Service Bulletin No. 325B

MODEL G4500 Series Coaches equipped w/ wheelchair	TYPE Field Change Program	SECTION/GROUP 3-Body	DATE Sept. 3, 2009
SUBJECT WHEELCHAIR LIFT (WCL) INTERLOCK DOOR RETROFIT			
CONDITIONS

THIS BULLETIN SUPERSEDES SERVICE BULLETIN 325 IN ITS ENTIRETY.

Ref. NHTSA Recall No.: 09V-345

Figure 3. Gusset installation corner (top, rearward corner of the lift access compartment).

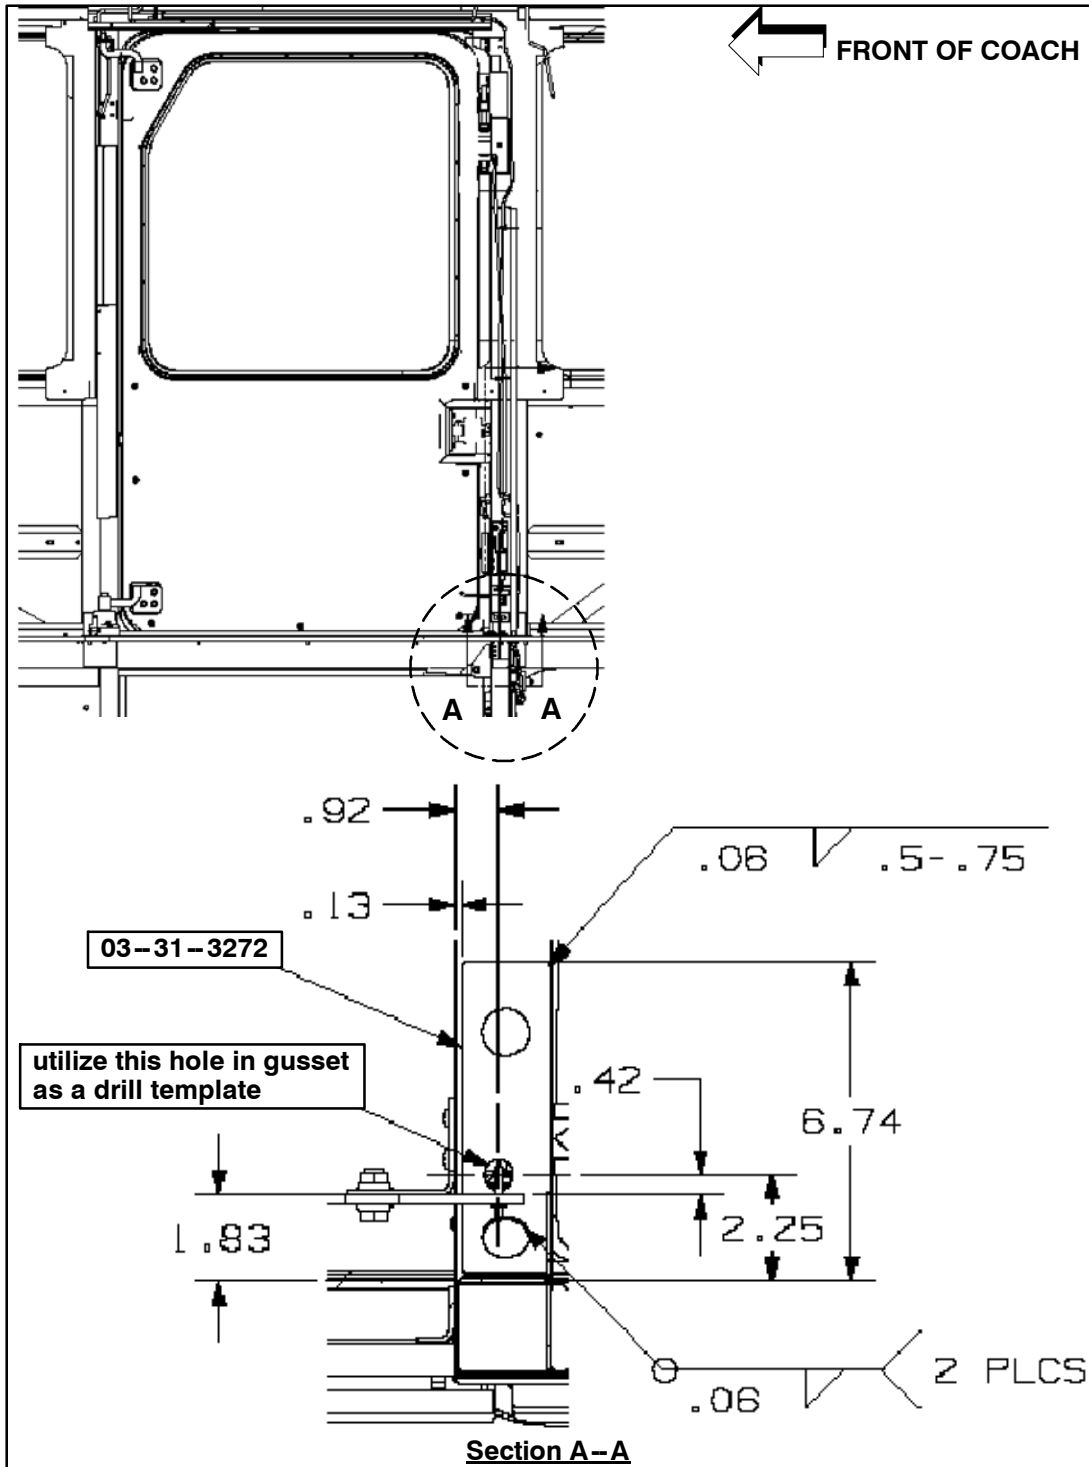
4. Locate and open the lift access compartment door, directly below the sliding wheelchair access door.
5. Using an industrial heat gun and steel brush, clean to remove all the dirt and loose paint or rust from the installation area (refer to Figures 3 and 4).
6. Tack weld the gusset (p/n 03-31-3272) into position, according to Figure 3.
7. Weld the gusset, using the weld sizes and locations in Figure 3.

Figure 5.

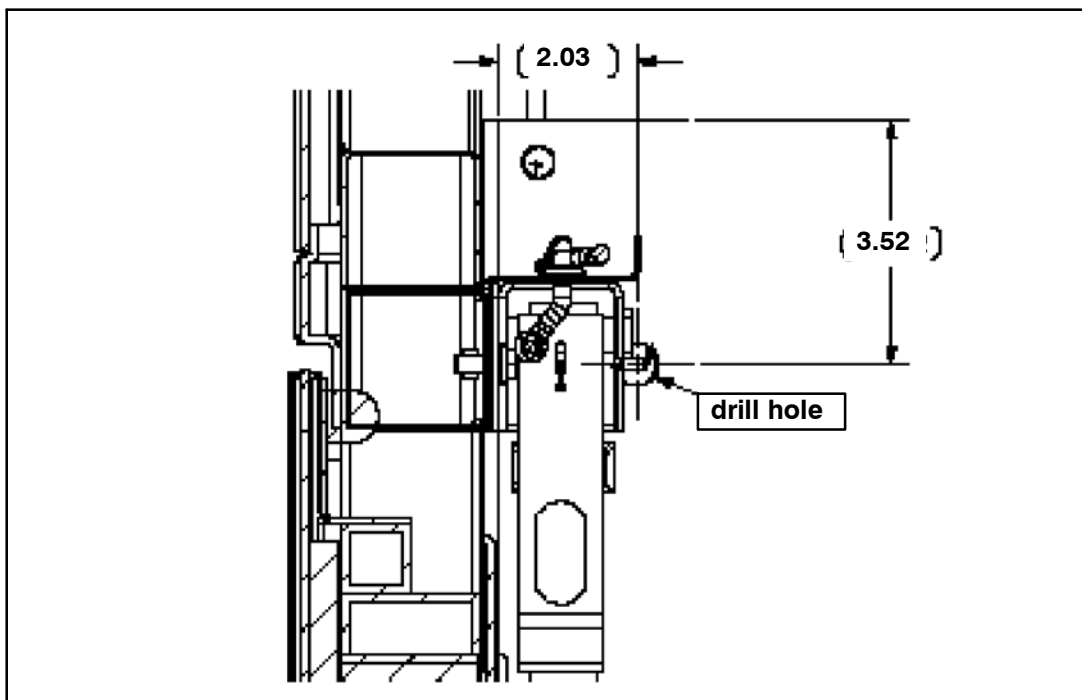
- 8. Using a 0.63 inch drill bit and the hole in the gusset as a template, drill a hole up through the tube frame and floor per the dimensions shown in Figure 5 into the coach cabin (refer to Figures 3 and 4 for hole location on gusset).

Figure 6. installation dimension.

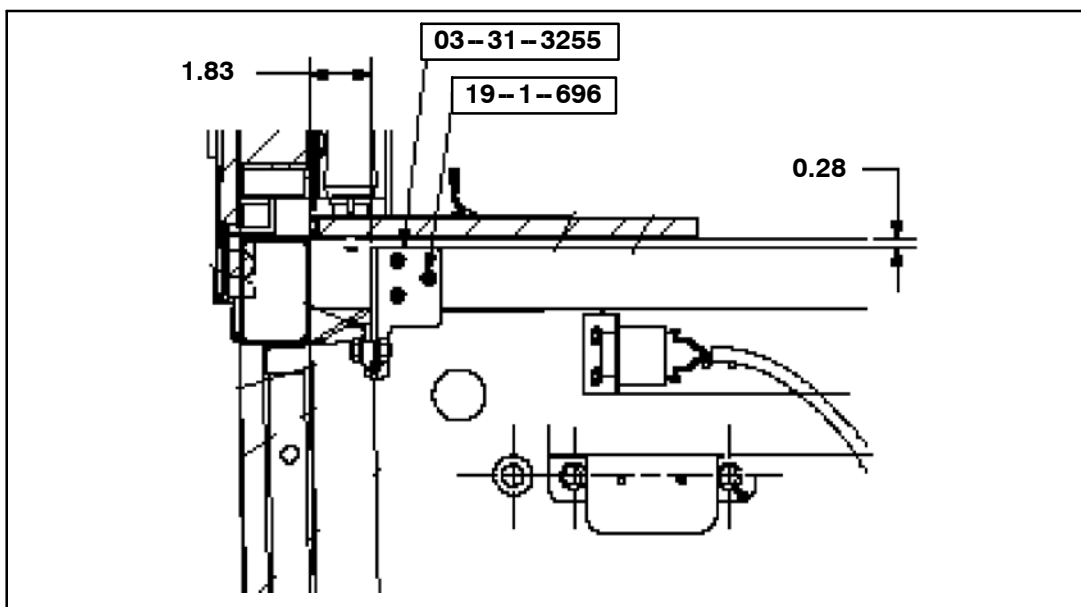
9. Position bracket, lever, p/n 03-31-3255, as shown in Figures 6 and 7.

Figure 8.

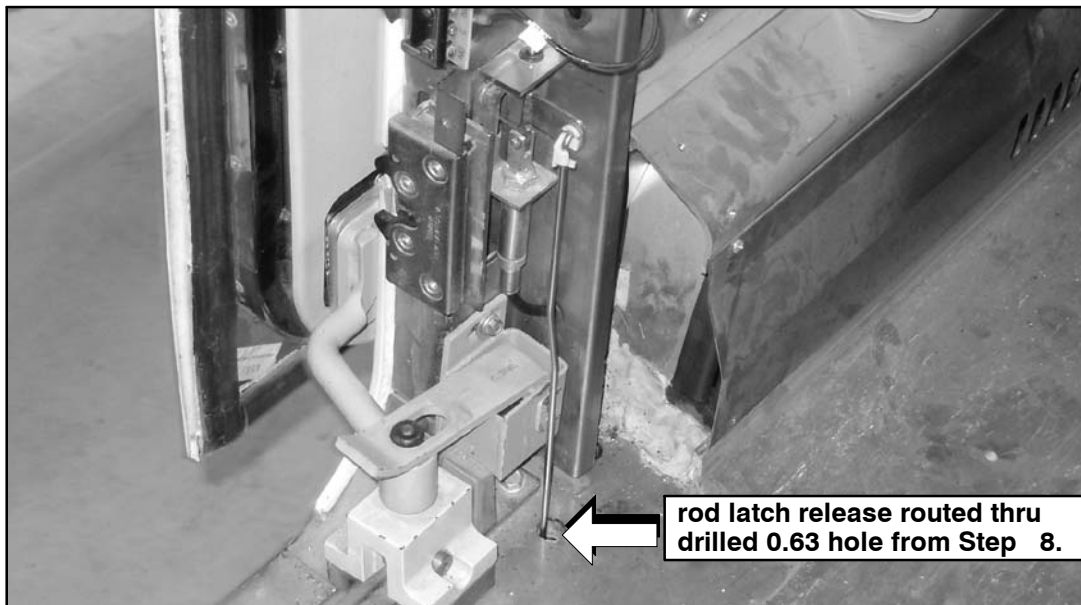
12. Remove and retain the four (4) mounting screws from the existing lever assy–latch. Discard existing lever assy–latch. Using the four (4) mounting screws, install the new lever assy–latch, p/n 03–31–3257 (refer to Figure 8). Tighten screws to secure.

Figure 12.

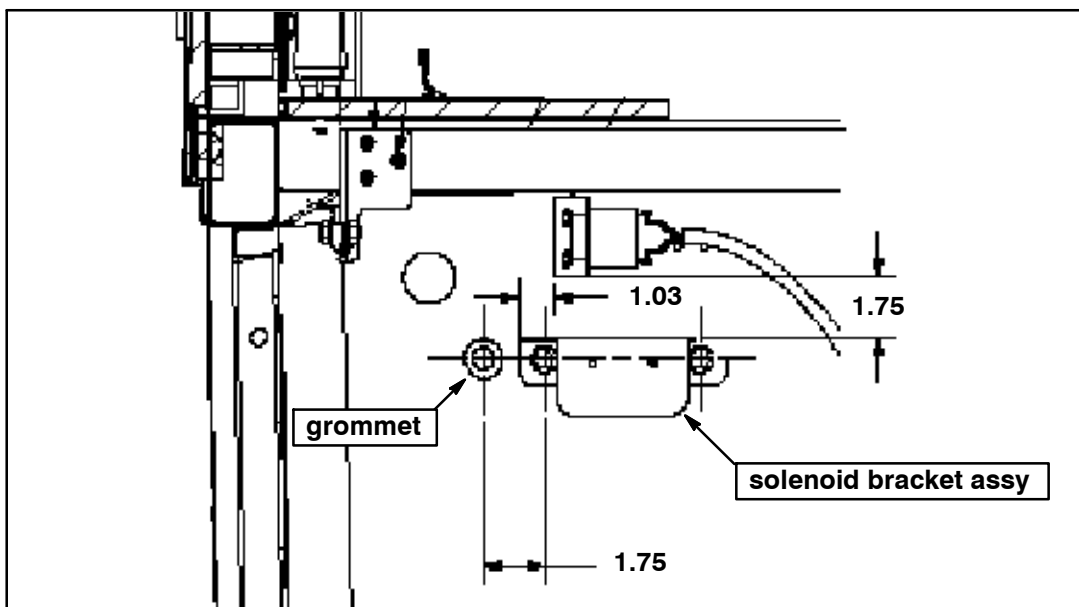
15. Position the solenoid bracket assy, p/n 03-31-3265, on the side panel of the lift access compartment as per dimensions shown in Figure 12 (refer to Figures 12 and 13).
16. Using a 0.34 inch drill bit and the two (2) holes in the solenoid bracket assy as a template, drill two (2) mounting holes. Using capscrew, p/n 19-1-16, fender washer, p/n19-2-187 and locknut, p/n 19-3-183, securely mount the solenoid bracket assy to compartment wall.
17. Using a 0.87 inch drill bit, drill a hole as per dimensions shown in Figure 12. Install grommet, p/n 19-12-20, in drilled hole (refer to Figures 12 and 13).

Figure 15.

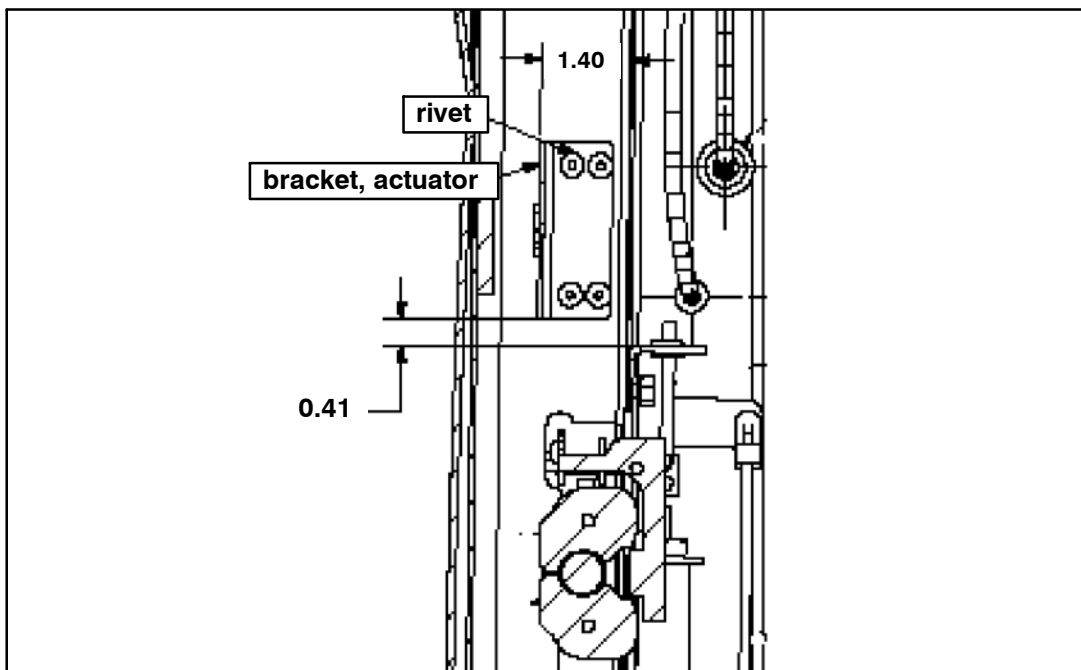
19. Using the two dimensions (1.40 and 0.41) shown in Figure 15, position the bracket, actuator, p/n 03–31–3281, and secure in place. Using a 0.20 drill bit and the four (4) holes in the bracket, actuator as a drill template, drill four mounting holes into the frame. Using rivets, p/n 19–13–137, mount the bracket, actuator to the frame (refer to Figures 15 and 16).

Figure 21. Schematic for non-multiplex coaches.

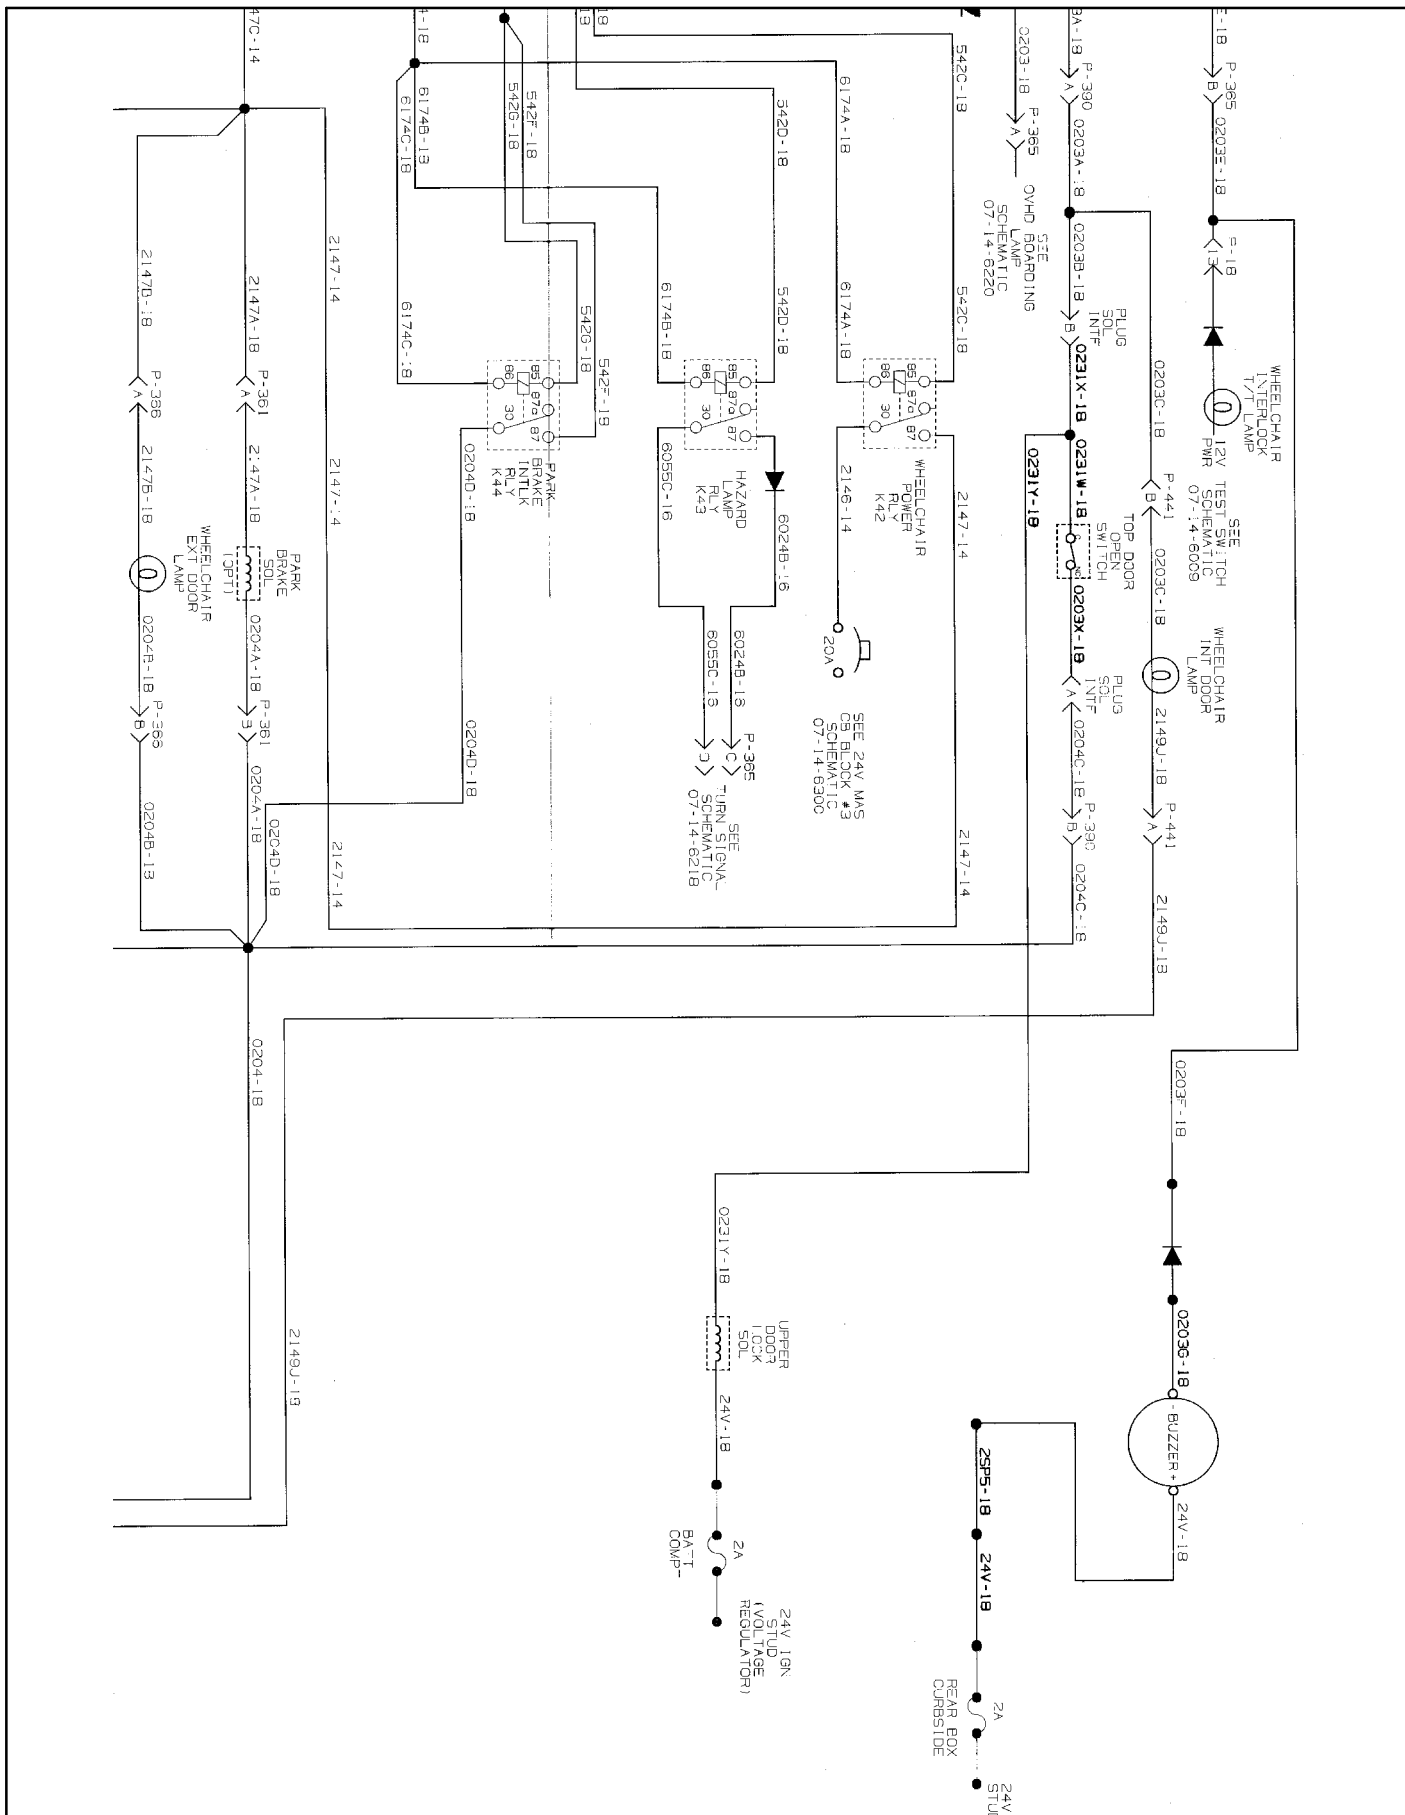
25. Use tywraps, p/n 19-11-569 throughout routing to secure harness to existing harnesses.
26. Remove ring terminals on existing harness that was disconnected in Step 20. Insert pins p/n 19-11-760, seals, p/n 19-11-2048, and connector, p/n 19-11-845 (refer to schematics in Figure 21 or 22).

27. Route existing harness and connect to harness adapter, p/n 07-12-3066.
28. Connect solenoid adapter harness to the switch and actuator removed in Step 20. , the assy-solenoid p/n 03-31-3265, and the 24V ignition terminal on the voltage regulator (refer to schematics in Figure 21 or 22).

Figure 23.

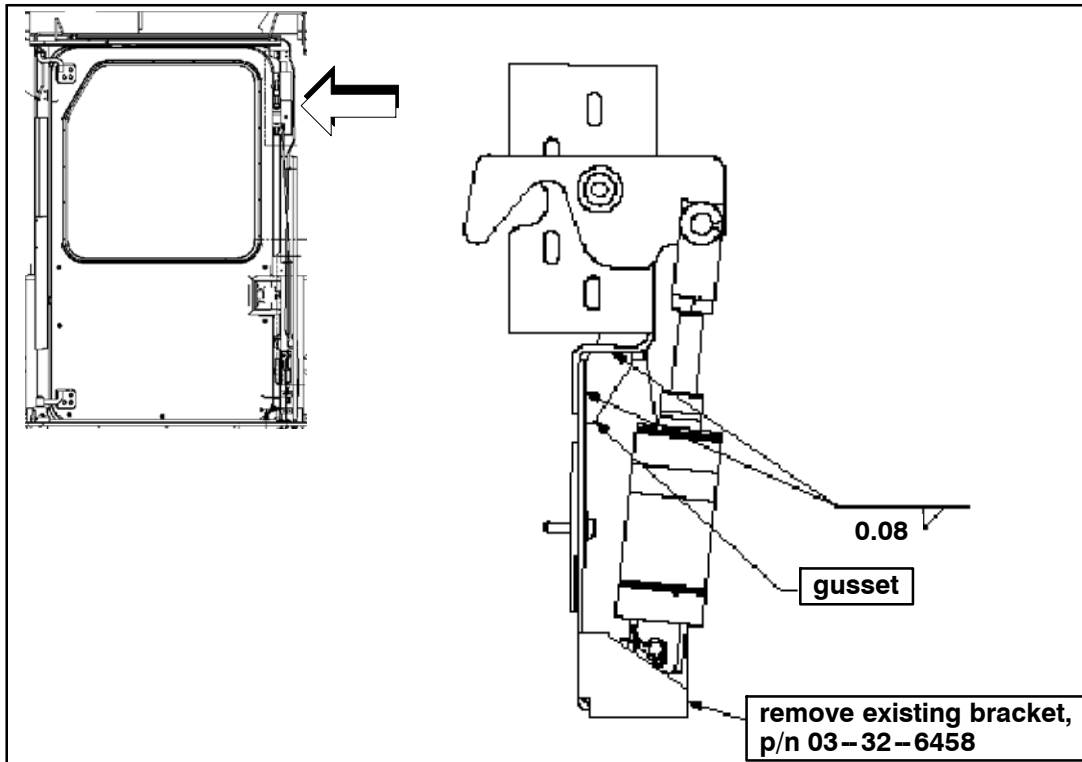
29. Remove existing bracket assy–cylinder upper, p/n 03–32–6458, from door (refer to Figure 23) and place on a workbench. Retain mounting hardware.
30. Position gusset, p/n 03–31–3261, as shown in Figure 23. Weld gusset flush on existing bracket assy–cylinder upper as per specifications shown in Figure 23.

Figure 24.

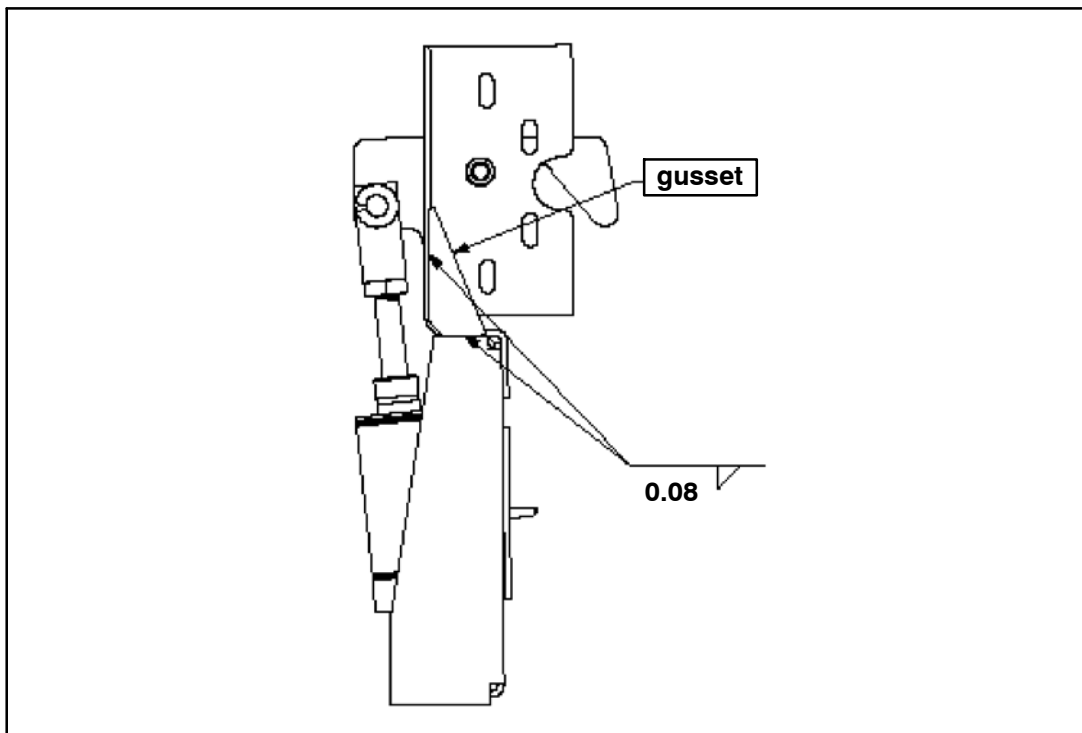
31. Position gusset, p/n 03–31–3260, as shown in Figure 24. Weld gusset flush on existing bracket assy–cylinder upper as per specifications shown in Figure 24.

Figure 25.

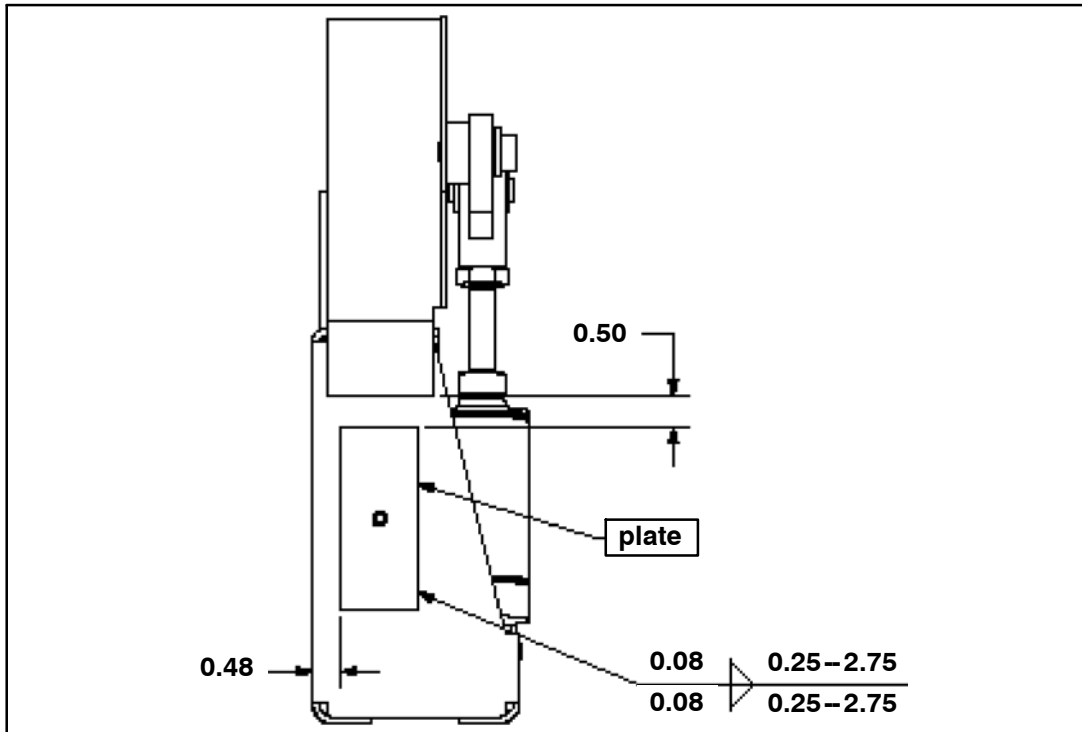
32. Position plate, p/n 03-31-3259, as per dimensions shown in Figure 25. Weld plate on existing bracket assy-cylinder upper as per specifications shown in Figure 25
